Staff Report for Item 12b

Applicant: Meridian Engineering/ Richard Milelli, Engineer

Application Number: H15-01-0006

Address: #1321 South Street

#1321 South Street Sanborn map 1948

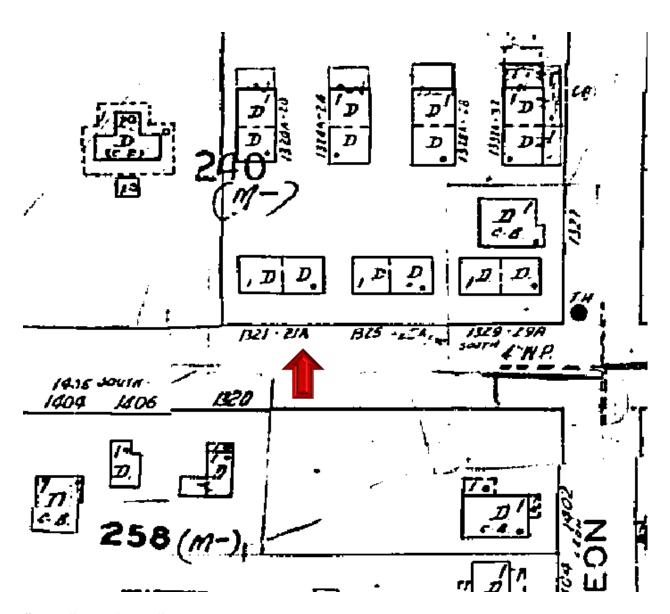
footprint proportions as the footprint depicted in the 1948 and 1962 Sanborn maps. The exterior walls have been stucco and the covered front porch is not original to the building. The building was part of a development of 11 other small duplexes that surrounded the historic Thompson House.

SITE PLAN 1/8" = 1' - 0"

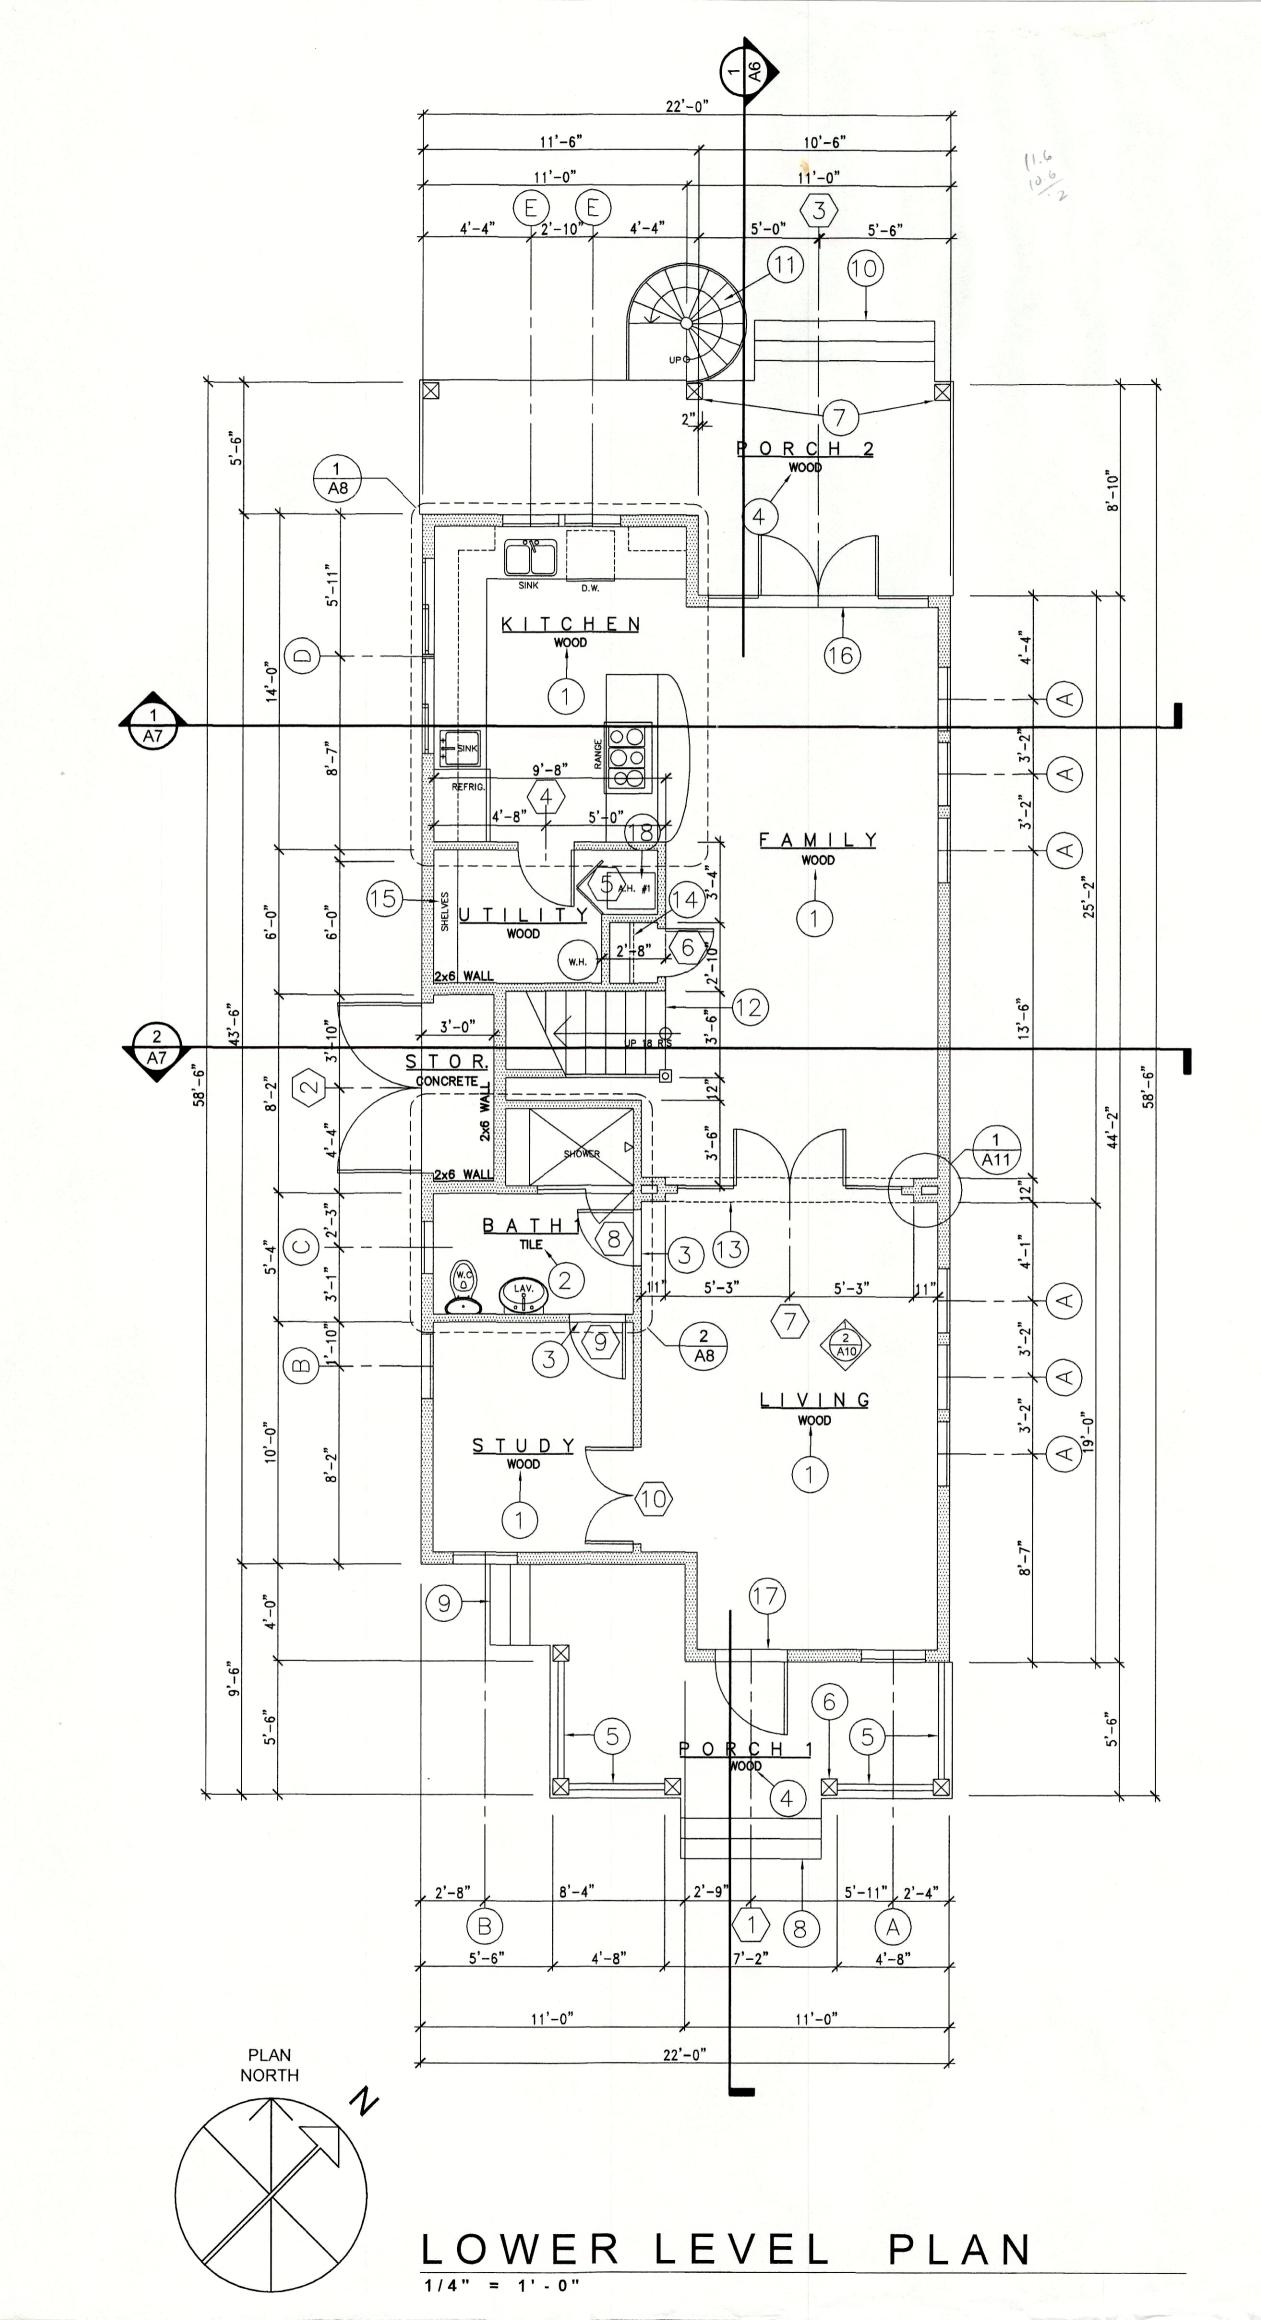
- Ms. Eables stated that they were replacing because of flooding.
- Mr. Batty asked if there was any reason why they were going with a bigger fence rather than something smaller.

- Mr. Knoll stated because it was traditional.
- Mr. Batty stated that no it's not.
- Mr. Mancini stated that it should be decorative. He stated that people do such a wonderful job and then cover up so you can't see it.

- Mr. Knoll stated that he doesn't want to be argumentative. He stated that standing in front of 4 ft. fence you can see over.
- Mr. Batty stated that was true but from the center of the street you can't see the porch. He stated that traditionally all fences remain at 36 in. or lower. He stated that he feels strongly about this because it is a part of the Historical District that it getting lost.

- Mr. Knoll stated that his client was willing to comply with that.
- Mr. Batty stated that they try to stay clear of the maximum and brining it to 36 in. would make them very happy.

Mr. Batty made a motion to approve with changes of fence reduced to a height of 36 in.

APPRO	VE	X with	changed	of fence	to a	reduced	height	of 36
inches	DISAPPROVE	TAE	BLE
